# UNITED STATES PATENT AND TRADEMARK OFFICE

APPLICATION NO.	FILING DATE	FIRST NAMED INVENTOR	ATTORNEY DOCKET NO.	CONFIRMATION NO.
10/051,433	01/18/2002	Geoffrey Hamilton White	PAT-1285DIV	5904

<b>Office Action Summary</b>	Application No.	Applicant(s)	
	10/051,433	WHITE ET AL.	
	Examiner	Art Unit	
	Brian E Pellegrino	3738

## DETAILED ACTION

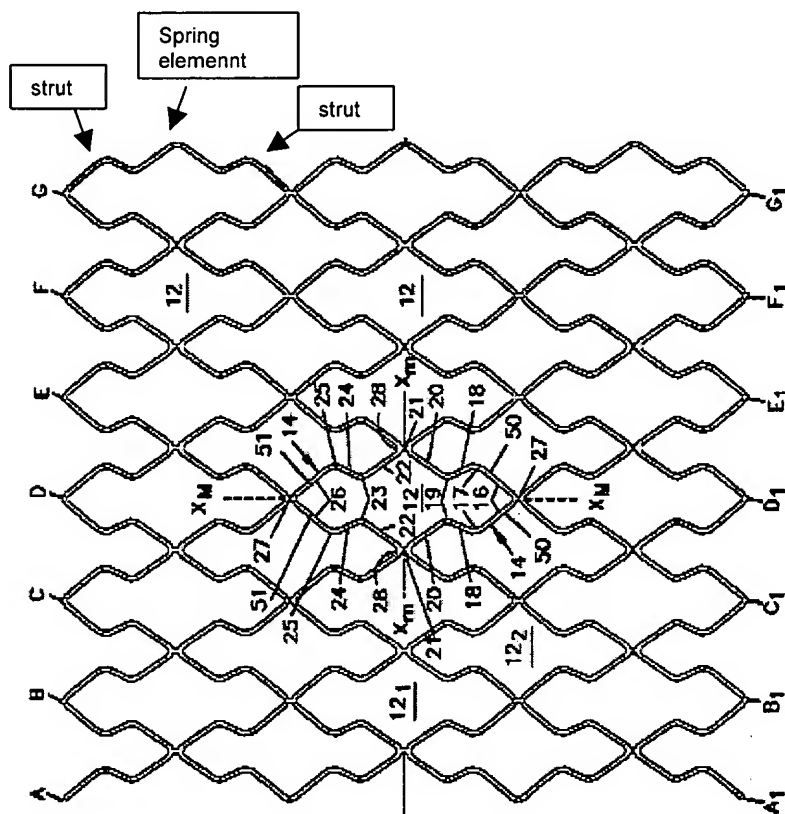
Claims 23-26, 29, 31-37, 40, 42-49, 52, 54-60, 63, 65-67 are rejected under 35 U.S.C. 103(a) as being unpatentable over Thompson (6132460). Fig. 3 shows a stent with a plurality of cells defining longitudinal rows (B-G) where adjacent longitudinal rows are inversely symmetrical to other longitudinal rows. It can be seen that adjacent cells are directly connected to an adjacent cell and cells are formed of exactly four struts.

The cells have at least four bends extending outside the cell and since claims 29,40,52,63 do not recite only or exactly four bends extend outside the cell, Thompson's cells with more than four bends extending outside the cell meet the limitation. However, Thompson does not disclose the plurality of cells being non-symmetrical about the longitudinal axis. It would have been an obvious matter of design choice to modify the cell symmetry, since applicant has not disclosed that using non-symmetrical structure provides any advantage, or solves a stated problem, or is used for any particular purpose. One of ordinary skill in the art, furthermore, would have expected Applicant's invention to perform equally well with the cell pattern taught by Thompson or the claimed cells being non-symmetrical about the longitudinal axis in claim(s) 23-26,29,31-37,40,42-49,52,54-60,63,65-67 because both Thompson's cells and the claimed non-symmetrical cells perform the same function of being highly flexible before and after expansion.

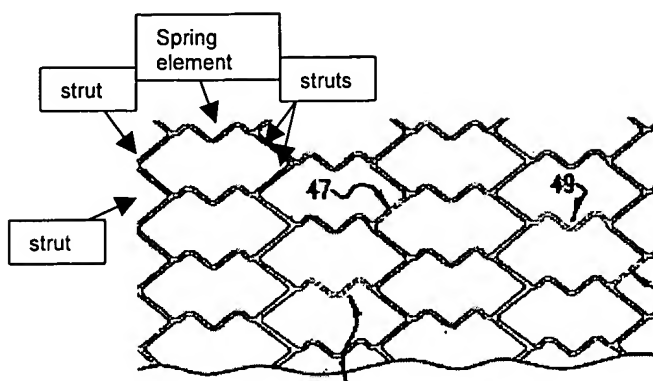
Claims 23-26,28,29,31-37,39,40,42-49,51,52,54-60,62,63,65-67 are rejected under 35 U.S.C. 103(a) as being unpatentable over Roubin et al. (WO 98/34668). Fig. 9 shows a stent with a plurality of cells defining longitudinal rows, wherein adjacent longitudinal rows are inversely symmetrical to other longitudinal rows. It can be seen that adjacent cells are directly connected to an adjacent cell and cells are formed of exactly four struts. The cells have at least four bends extending outside the cell and since claims 29,40,52,63 do not recite only or exactly four bends extend outside the cell, Roubin's cells with more than four bends extending outside the cell meet the limitation.

However, Roubin et al. do not disclose the plurality of cells being non-symmetrical about the longitudinal axis. It would have been an obvious matter of design choice to modify the cell symmetry, since applicant has not disclosed that using non-symmetrical structure provides any advantage, or solves a stated problem, or is used for any particular purpose. One of ordinary skill in the art, furthermore, would have expected Applicant's invention to perform equally well with the cell pattern taught by Roubin et al. or the claimed cells being non-symmetrical about the longitudinal axis in claim(s) 23-26,28,29,31-37,39,40,42-49,51,52,54-60,62,63,65-67 because both Roubin's cells and the claimed non-symmetrical cells perform the same function of being highly flexible before and after expansion.

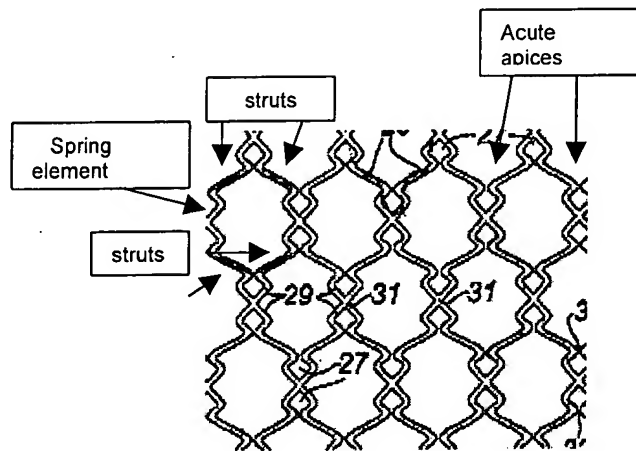
Claims 23,24,26,27,29-32,34,35,37,38,40-43,45-50,52-55,57-59, 61,63-66 are rejected under 35 U.S.C. 103(a) as being unpatentable over Milo (6206911). Fig. 2 shows a stent with a plurality of cells defining longitudinal rows, wherein adjacent longitudinal rows are inversely symmetrical to other longitudinal rows. It can be seen that adjacent cells are directly connected to an adjacent cell and cells are formed of exactly four struts. The cells have at least four bends extending outside the cell and

since claims 29,40,52,63 do not recite only or exactly four bends extend outside the cell, Milo's cells with more than four bends extending outside the cell meet the limitation.

The cells have at least three bends defining acute apices or internal angles that are less than ninety degrees. Since claims 27,30,38,41,50,53,61,64 do not recite only or exactly three bends with acute angles, Milo's cells having four acute angles meet the claim limitations. However, Milo does not disclose the plurality of cells being non-symmetrical about the longitudinal axis. It would have been an obvious matter of design choice to modify the cell symmetry, since applicant has not disclosed that using non-symmetrical structure provides any advantage, or solves a stated problem, or is used for any particular purpose. One of ordinary skill in the art, furthermore, would have expected Applicant's invention to perform equally well with the cell pattern taught by Milo or the claimed cells being non-symmetrical about the longitudinal axis in claim(s) 23,24,26,27,29-32,34,35,37,38,40-43,45-50,52-55,57-59, 61,63-66 because both Milo's cells and the claimed non-symmetrical cells perform the same function of being highly flexible before and after expansion.
